Charlotte-Mecklenburg Planning, Design, & Development

SUBJECT: Administrative Approval for Petition No. 2019-062 Suncrest Real Estate and

Modification to the overall site plan to adjust proposed road network and remove a proposed road out of the railroad right-of-way.

REZONING ADMINISTRATIVE AMENDMENT **PETITION 2019-062**

RZ-2.0

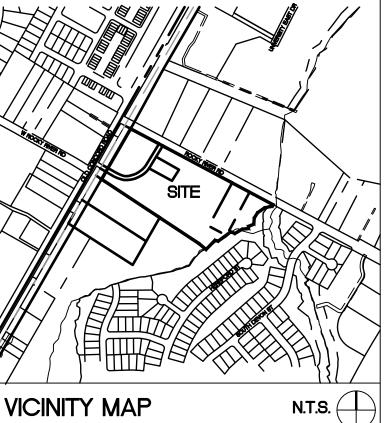
09-14-21 Administrative Amendment per City of <u>✓1</u>Charlotte Zoning requirement

RZ-3.0

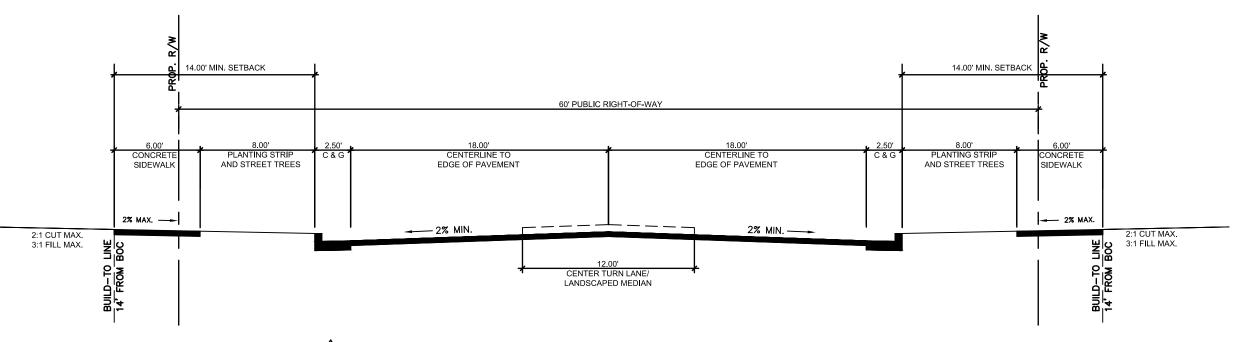
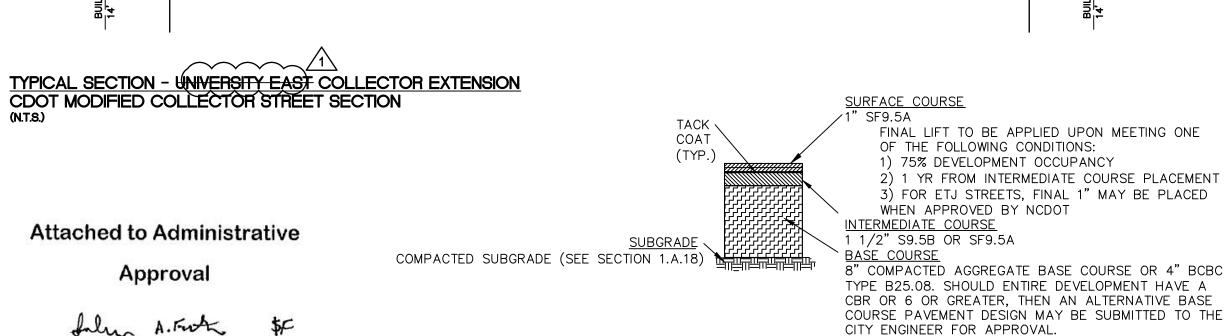
- /1\ 7. The internal private street designated as Road C and the internal private drives may, at the option of Petitioner, be gated.
- 8. The on-street parking on Rocky River Road depicted on the Rezoning Plan may be constructed at the option of Petitioner provided that such on-street parking is approved by CDOT and/or NCDOT and any other applicable governmental agencies. If Petitioner elects not to construct such on-street parking or if such on-street parking is not approved by CDOT and/or NCDOT or any other applicable governmental agencies, Petitioner shall not be required to construct the on-street parking.

Newell Farm Rd shall not be closed without providing an alternate route for public access. CDOT cannot abandon R/W until an alternate route is provided. If Road C is to be the substitute as public access, it must be placed in a public access easement. No gates will be allowed on that section of Road C. Construction staging plans should be included in permitting documents to ensure that safe access to properties south of the development are maintained throughout and after construction.
